SUBJECT: ISSUANCE OF AMENDMENT NO. 91 TO FACILITY OPERATING LICENSE
NO. NPF-2 AND AN AMENDMENT NO. 84 TO FACILITY OPERATING LICENSE NO.
NPF-8 INCREASE IN RELOAD FUEL ENRICHMENT - JOSEPH M. FARLEY
NUCLEAR PLANT, UNITS 1 AND 2, (TAC NOS. M80893 AND M80894)

AMENDMENT NO. 91 TO FACILITY OPERATING LICENSE NO. NPR-2 - FARLEY, UNIT 1
AMENDMENT NO. 84 TO FACILITY OPERATING LICENSE NO. NPF-8 - FARLEY, UNIT 2

SAFETY EVALUATION BY THE OFFICE OF NUCLEAR REACTOR REGULATION
RELATED TO AMENDMENT NO. 91 TO FACILITY OPERATING LICENSE NO. NPF-2
AND AMENDMENT NO. 84 TO FACILITY OPERATING LICENSE NO. NPF-8

Farley Units 1 & 2 Spent Fuel Storage Minimum IFBA Requirements

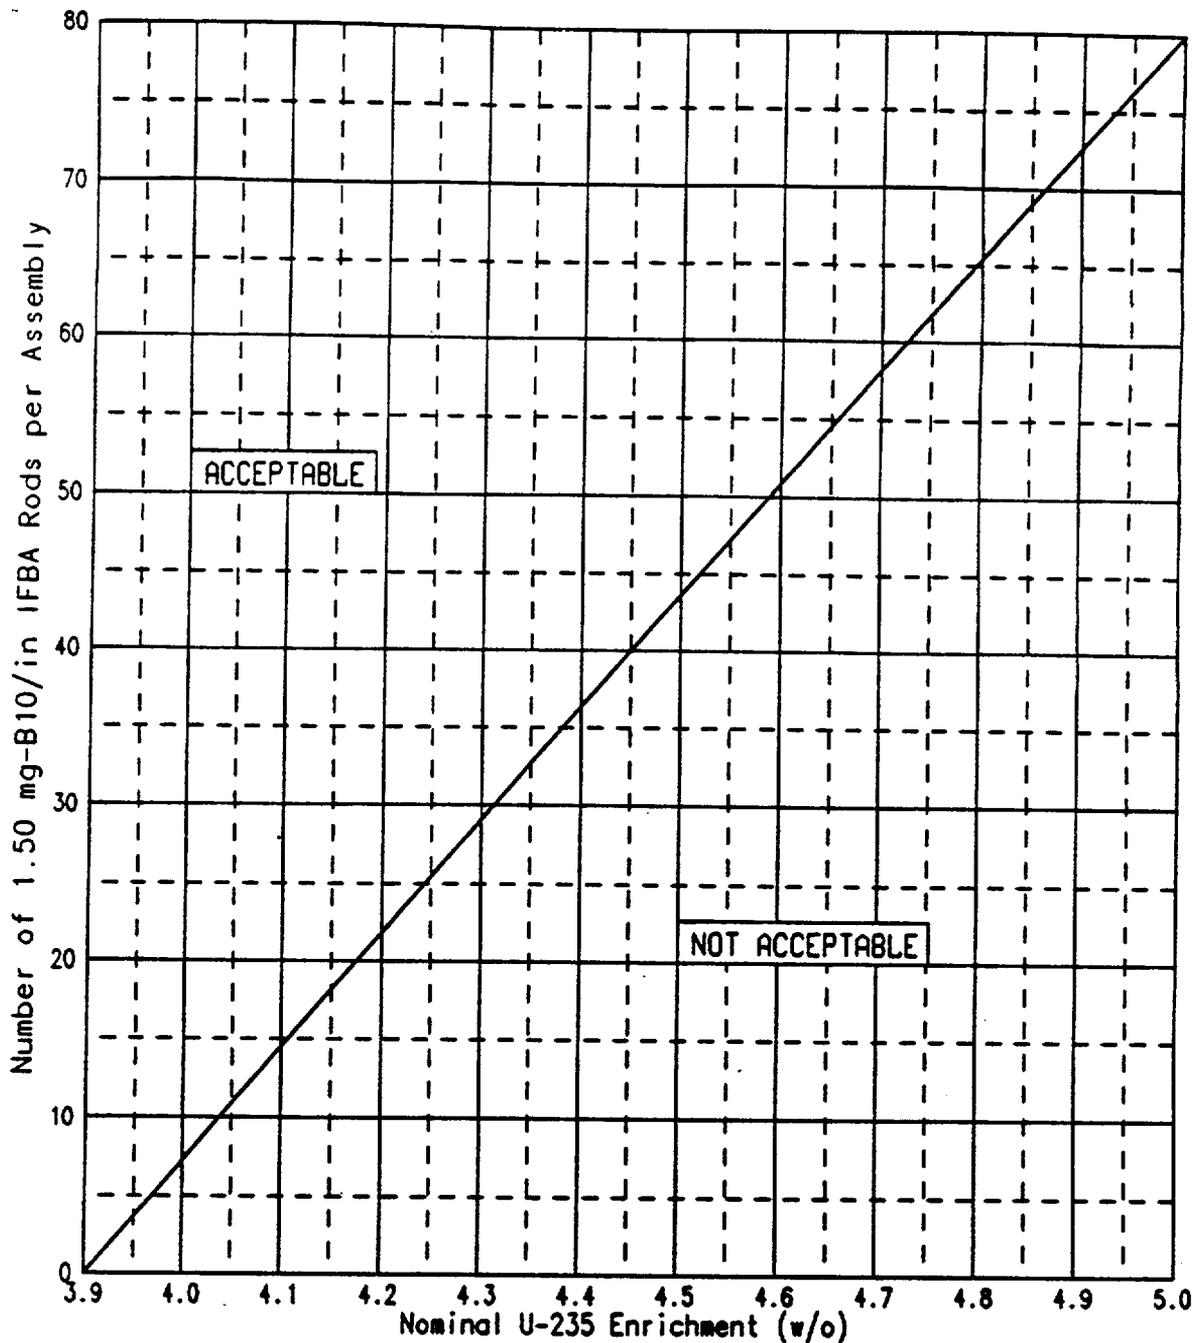
The concept of reactivity equivalencing is predicated upon the reactivity decrease associated with the addition of IFBA fuel rods. A series of reactivity calculations are performed to generate a set of IFBA rod number versus enrichment ordered pairs which all yield the same k-eff when the fuel is stored in the spent fuel racks. This is shown in the attached figure (from the Westinghouse report, "Criticality Analysis of the Farley Units 1 & 2 Fresh and Spent Fuel Racks" of March 1991, provided by the licensee in its request of July 1, 1991) which shows that the rack reactivity of fuel with 80 IFBA rods

with an initial enrichment of 5.0 w/o U-235 is equivalent to the rack reactivity of fresh (unirradiated) fuel having an initial U-235 enrichment of 3.9 w/o U-235 and containing no IFBA rods. This equivalence relationship assures the maximum k-eff will be calculated since depletion calculations performed by the licensee have shown that the maximum reactivity of the Westinghouse fuel assemblies occurs at zero burnup for any number of IFBA rods per assembly. This method of reactivity equivalencing has been used by other licensees for fuel storage analyses and has been accepted by the staff.

In order to simplify verification of acceptability for storage of fuel in the spent fuel racks, a k-infinity for a fresh 3.9 w/o U-235 fuel assembly was determined. As mentioned earlier, this is equivalent to the reactivity of a 5.0 w/o U-235 fuel assembly with 80 IFBA rods. When k-infinity is used as a reference reactivity point, the need to specify an acceptable enrichment versus number of IFBA rods correlation is eliminated. Calculation of k-infinity for a fuel array of 5.0 w/o fuel in the Farley reactor core geometry resulted in a reference value of 1.455. The licensee has shown that fuel with a reference k-infinity of 1.455 results in a maximum k-eff of less than 0.95 when stored in the Farley spent fuel storage racks. Therefore, the only requirement needed to ensure that the fuel racks are maintained at a k-eff below 0.95 is to verify that for each assembly, the k-infinity is no greater than 1.455 at 68°F in the core geometry.

Based on the evaluation of criticality aspects of storage, the staff concludes that the Farley, Units 1 and 2, new and spent fuel storage racks can accommodate Westinghouse OFA and VANTAGE-5 fuel assemblies with maximum nominal enrichments of 5.0 w/o U-235 provided that the fuel assemblies with enrichment greater than 3.90 w/o U-235 contain sufficient IFBAs such that the maximum core geometry k-infinity of these assemblies is no greater than 1.455 at 68°F. Farley TS 5.3.1 has been modified to incorporate this requirement.
